To	City of Ukiah		
Copy to	GHD Files		
From	GHD and Northern Hydrology & Engineering	Tel	+1 415 283 4970
Subject	City of Ukiah FEMA Map Revision Review	Project no.	12589077

MEMORANDUM

1. Review Summary

Figure 1. Effective FIRM Panel 06045C1514F (June 2, 2011)

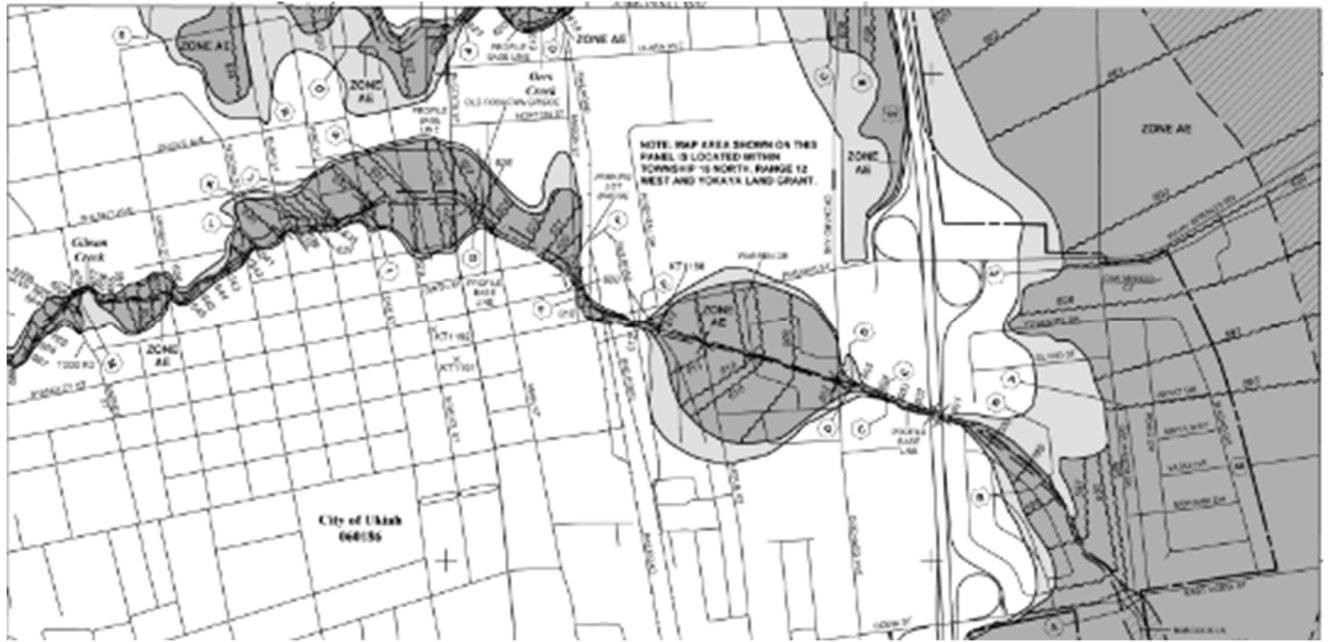
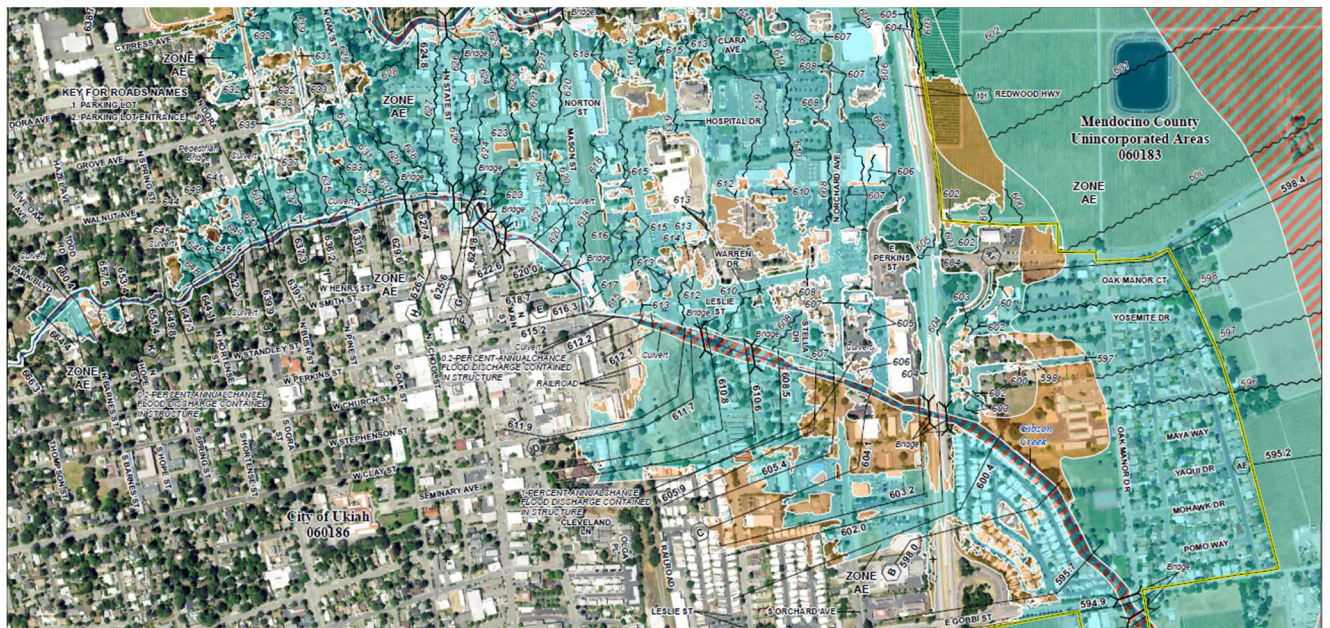
The preliminary FIRM shows proposed changes in the floodplain extent in the City. The preliminary FIRM generally shows additional floodplain areas, especially for Zone A and Zone AE. For example, in FIRM panel 06045C1514, a significant portion of the urban area between Orrs Creek and Gibson Creek is remapped as floodplain Zone AE, as shown in Figures 1 and 2. The changes are partly due to a different hydraulic analysis approach in this floodplain area. The hydraulic analysis for the effective FIRM was based on one-dimensional (1-D) creek modeling. The new hydraulic analysis for the preliminary FIRM included 1-D modeling and limited two-dimensional (2-D) floodplain modeling to provide additional resolution to the floodplain flooding. These updates of floodplain extents in the preliminary FIRM may trigger new flood insurance requirements in the area.

The impetus for this review of the preliminary FIRM update concerned the large expansion of the SFHA along and between Orrs Creek and Gibson Creeks (Figures 1 and 2) within the City (Tim Eriksen, City of Ukiah City Engineer, personal communication). Based on comments and feedback from a long-time local engineer (Ron Franz) who has completed hundreds of Elevation Certificates in the City limits, flooding in these expanded SFHA areas has not occurred, even during the December 2005 flood event (Ron Franz, personal communication). For reference, the 30 December 2005 flood event on the Russian River near Ukiah (USGS station: 11461000) observed peak flow was 22,600 cfs and exceeded the 1% annual exceedance flow (100-yr event) of 22,100 cfs estimated by the USGS (Gotvald et al. 2012) for this station.

Figure 3. 2-D model domain for the Orrs Creek/Gibson Creek intermingled floodplain flow

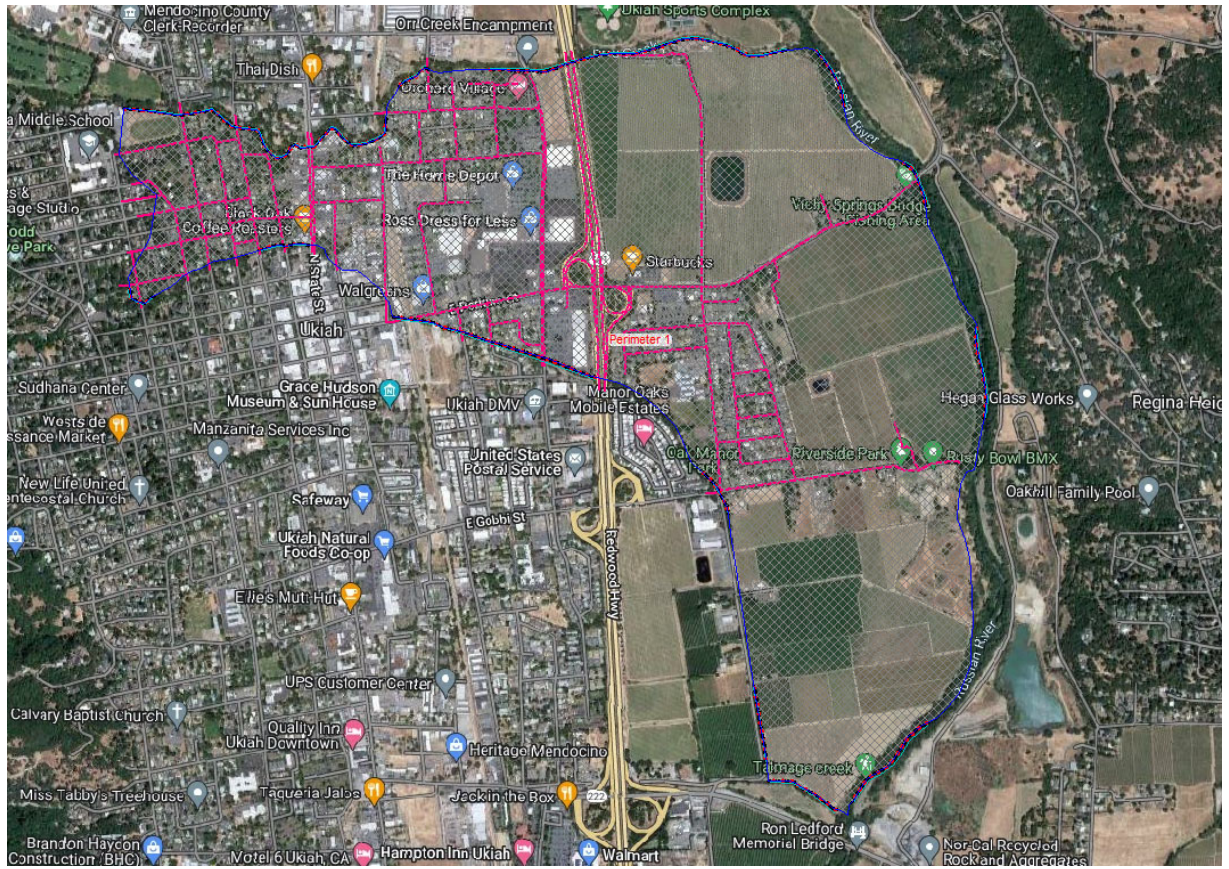
The STARR II 1-D/2-D analysis consisted of developing three separate HEC-RAS models. For Orrs Creek, the 1-D model cross-sections terminated along the right channel top of bank and these cross-section ends were connected by a series of lateral structures. A similar approach was used for Gibson Creek, but the cross-sections were terminated and connected by lateral structures along the left bank. The 2-D floodplain mesh was trimmed to align with the lateral structures (ends of the cross-sections) along Orrs and Gibson Creeks. HEC-RAS allows the 2-D floodplain mesh to be connected to the 1-D lateral structures, creating a 1-D/2-D hydraulic model that dynamically simulates the flow exchange between the channel and floodplain. In other words, the model can continuously simulate flows leaving the channel and flowing onto the floodplain or leaving the floodplain and reentering the channel based on topography and flow conditions. However, STARR II did not link the 1-D and 2-D models and instead attempted to conduct the 1-D and 2-D analysis separately. Although this approach can work in theory, it appears that the assumptions and analysis of the STARR II 1-D/2-D modeling approach was not accurately conducted, which resulted in unrealistic and physically impossible flow conditions and water surface elevations between Orrs Creek and Gibson Creek (1-D model) and the adjoining floodplain (2-D model).

Based on the STARR II report, the 1-D models of Orrs and Gibson Creeks were initially run and the flows going over the lateral structures were removed from the 1-D model and used as inflow boundary conditions for the 2-D model. However, flows from the 2-D model were not allowed to leave the 2-D mesh and reenter the 1-D models except near HWY 101 on Orrs Creek and between the railroad grade and HWY 101 on Gibson Creek. In other words, throughout the City west of HWY 101 and the railroad, floodplain base flood elevations are artificially elevated due to flows not being allowed to leave the 2-D model and reenter the 1-D model (creek channels). The STARR II modeling approach and assumptions have created inaccurate and physically impossible base flood elevations which can be seen in the preliminary FIRM map and supporting data.

Figure 5. FEMA defined Base Flood Elevations for the floodplain and adjacent Orrs Creek Cross Sections (Blue lines = floodplain BFE, Green lines = Cross-section location and WSE)

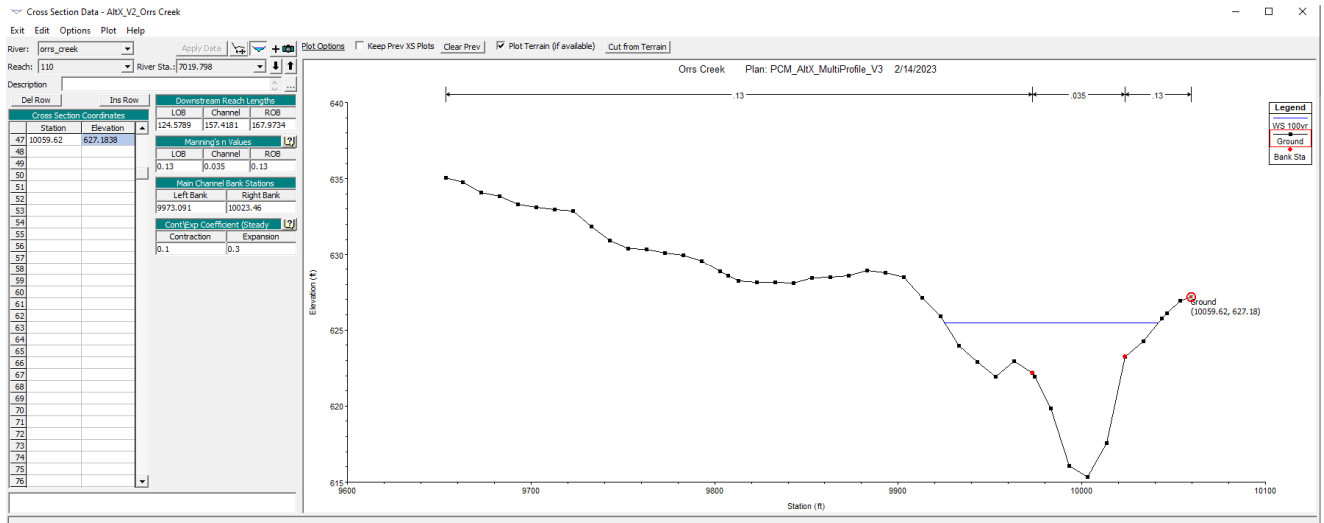
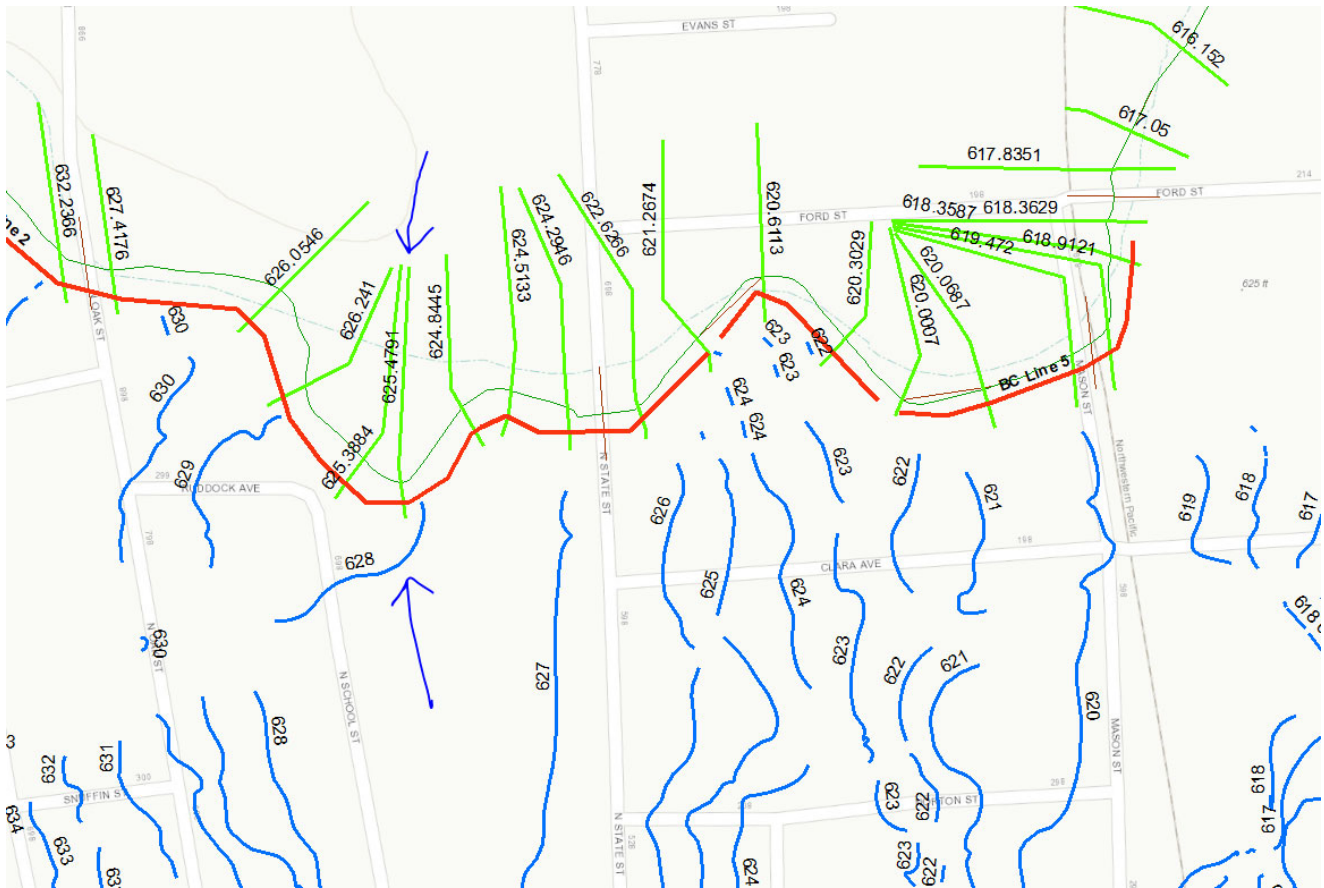
A review of the preliminary FIRM map and the spatial files provided by FEMA for the Base Flood Elevations within the floodplain reveal differences between the channel and floodplain water surface elevations, with floodplain water levels being higher and in some locations significantly higher than creek levels along much of the upper reaches of Orrs and Gibson Creeks. This difference occurs in locations where the 1-D channel is assumed to be contributing flow to the floodplain, which is physically impossible. An example of this is highlighted in Figures 4 and 5 for Orrs Creek Station 7019.798 and the adjacent floodplain-defined water surface elevation. The 2-D floodplain model has a boundary condition line distributing 240 cfs flow from the creek (1-D model) to the floodplain at this location. However, the 1-D model water surface elevation at this cross-section (625.48 ft.) is over 2.5 ft. lower than the water surface elevation in the adjacent 2-D model floodplain (628.0 ft.). Given the difference in water levels, this is a location where floodplain flow should be re-entering Orrs Creek, not leaving Orrs Creek. However, the model setup and assumptions prevent flow from re-entering the channel at this location.

Figure 6. Orrs Creek 100-Year water surface elevation (WSE) Profile with Lateral Structure elevation and adjacent Floodplain 100-Year WSE

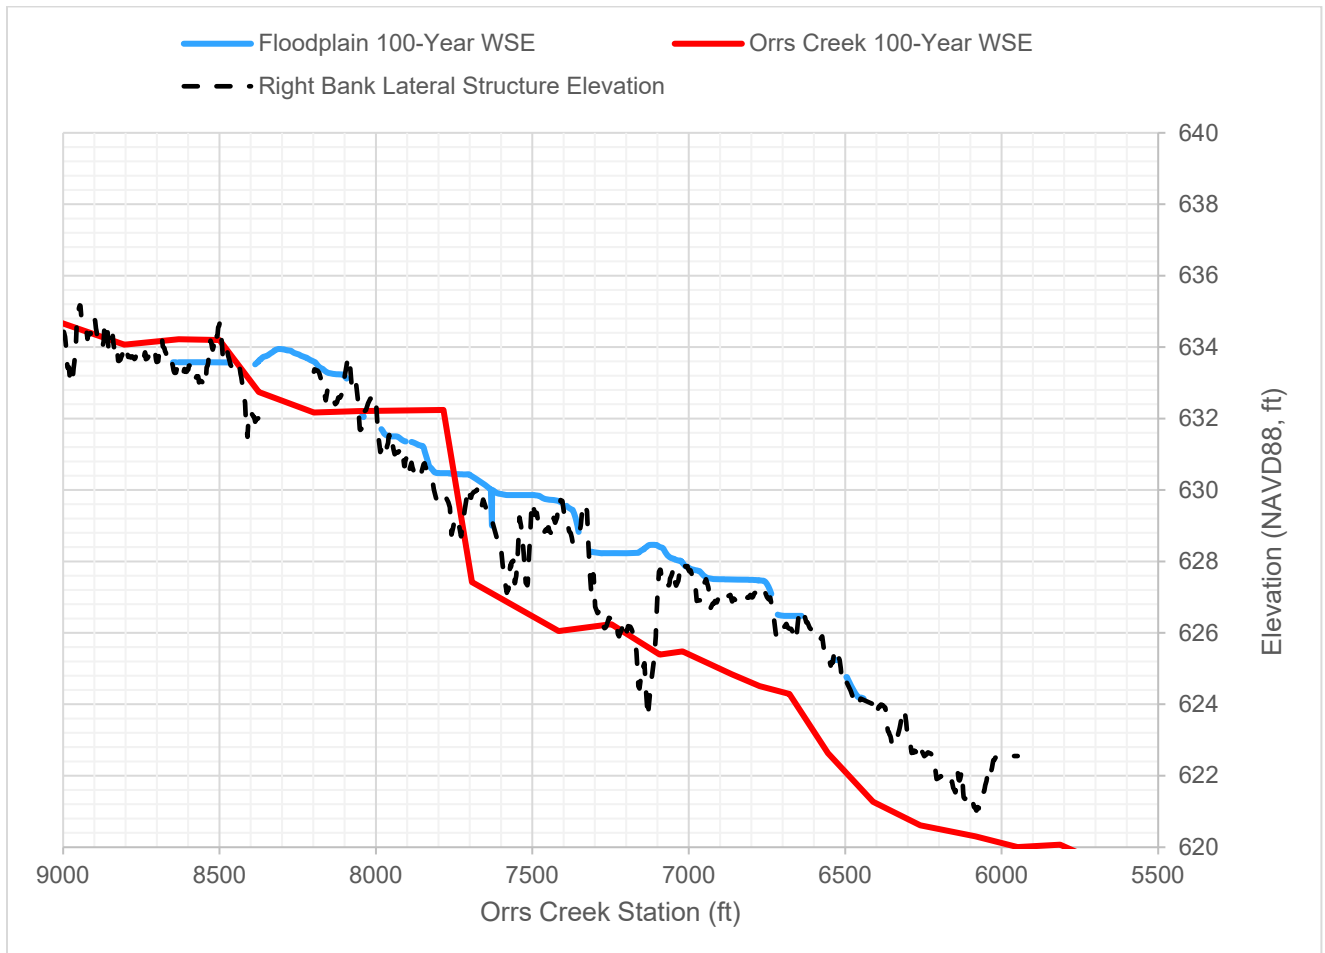
The above example for Orrs Creek is at a single location. However, this unrealistic difference in water levels between the floodplain and creek channels occurs along much of the length of Orrs Creek and Gibson Creek. Figure 6 displays the 100-year flood water surface elevation profiles for Orrs Creek (1-D model), the adjacent floodplain levels from the 2-D model, and the right-bank lateral structure elevations. There are two locations where creek levels are higher than the ground and floodplain water levels, and flows would leave the channel (1-D model) and enter the floodplain (2-D model). However, there are significantly more locations where floodplain flows are higher than the ground and creek levels and floodplain flows would want to reenter the channel at these locations. It should be noted that this condition occurs immediately downstream of the locations where flow leaves the channel, which tends to be at creek crossings. Unfortunately, the STARR II modeling assumptions and analysis do not allow floodplain flows from the 2-D model to reenter the creek (1-D model) along this section of Orrs Creek, which is unrealistically elevating floodplain depths and base flood elevations by artificially keeping flow in the floodplain. These differences in creek and floodplain water surface elevations can be seen along both reaches of Orrs Creek and Gibson Creek. Only east of the railroad grade near HWY 101, where floodplain flows are allowed to leave the 2-D model and reenter the 1-D model, do floodplain and creek water surface elevations realistically coincide.

Figure 7. Hydraulic profile (100-yr) of a section of Doolin Creek showing bridges/culverts controlling HGL

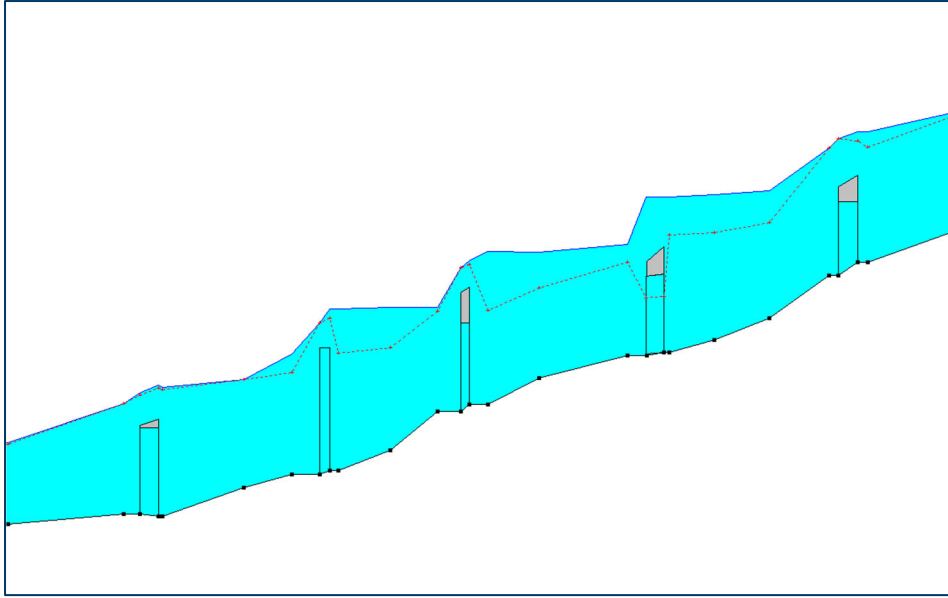
5. Based on the hydraulic profile for the Doolin Creek, it appears that many of the bridges and culverts along the channel are constrictions and control the upstream hydraulic profile as shown in Figure 4. All these structures are overtopped during the 100-yr flow, so the elevation of the bridge deck/roadway and the structure opening may have significant impacts on the hydraulic profile upstream of the structure. Per the Hydraulic Report, these structures were all surveyed, but we wanted to highlight this observation in case there is any uncertainty in the geometry of the structures.

Figure 3. Workmap Example

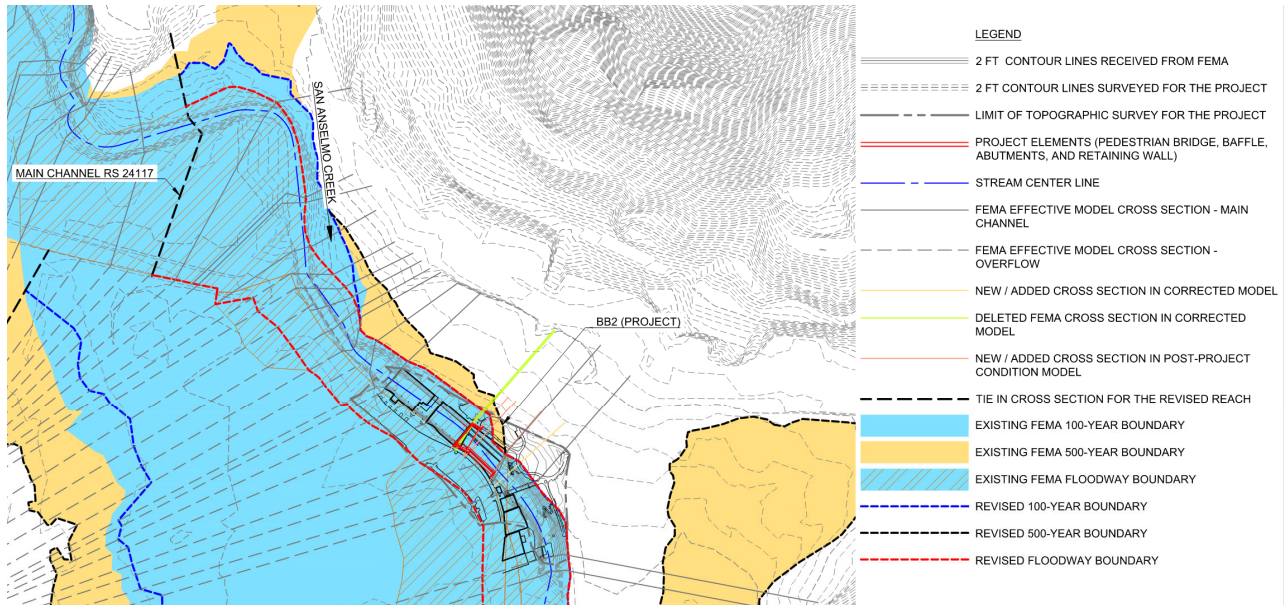
As a standard of practice, a workmap should be provided that shows the effective floodplain and floodway and the revised floodplain and floodway included in the Hydraulic Report. An example is provided below.

The workmap is an important tool for the review team to identify areas of change in the floodplain and floodway boundary. The review team would like to request this additional information from FEMA’s STARR II contractor team for review.
